**SUBJECT: Seneca Army Depot Activity, Final Action Memorandum and Final Decision Document for Time-Critical Removal Actions, Three VOC Sites (SWMUs SEAD-38, SEAD-39, and SEAD-40) at Seneca Army Depot Activity, Romulus, New York.**

**ACTION MEMORANDUM and DECISION DOCUMENT  
TIME-CRITICAL REMOVAL ACTIONS,  
THREE VOC SITES (SEADs 38, 39, & 40)**

**Response To Comments  
Submitted By  
U.S. Environmental Protection Agency (USEPA), Region II  
For Draft Final Action Memorandum and Decision Document Removal Actions,  
Three VOC Sites  
(SEADs 38, 39, 40)**

FIGURE 1-1  
SAMPLE LOCATIONS AND  
APPROXIMATE AREA  
TO BE REMEDIATED

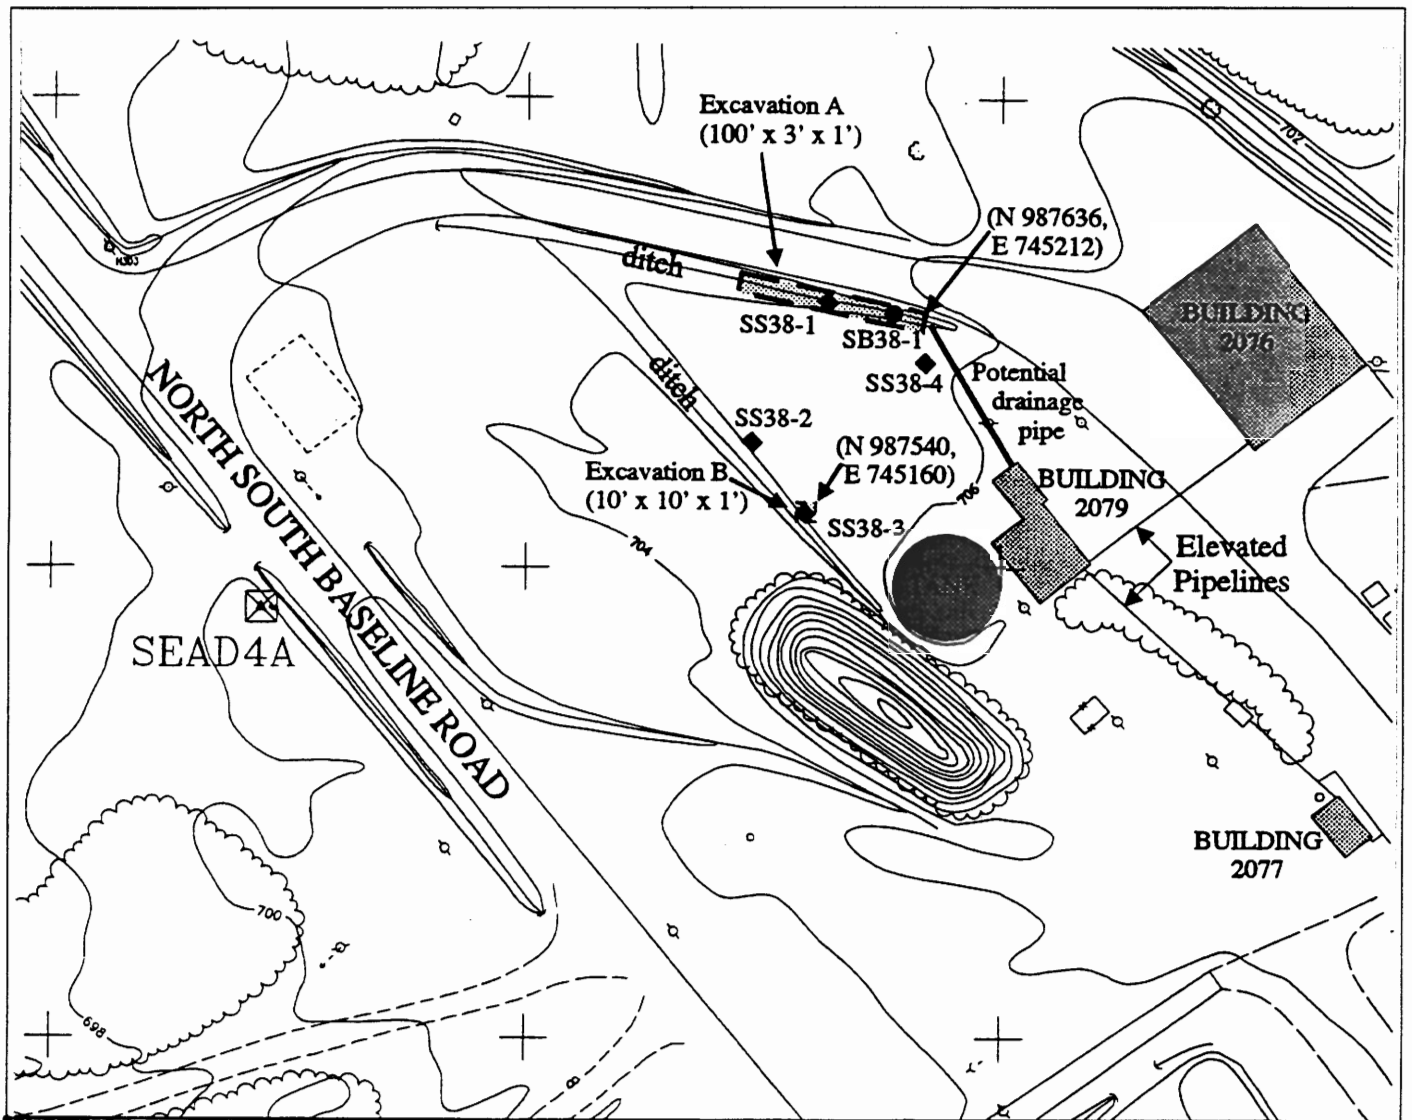
3. **SEAD-38 Decision Document, Figure 1-1:** The text in Section 1.1 references the location of the Burning Pit boundary in the description of the areas to be excavated. Add the location of the Burning Pit to Figure 1-1 for clarity.

The sentence referencing the Burning Pit in the second paragraph of Section 1.1 was not properly edited before the draft was issued. The referenced Burning Pit is located at SEAD-24, the Abandoned Powder Burning Pit. The Decision Document for SEAD-24 was in preparation at the same time as the Decision Document for SEAD-38, and the text provided in the identified paragraph for SEAD-38 was apparently cut and pasted from the SEAD-24 document. The second paragraph for the SEAD-38 Decision Document has been revised to read:
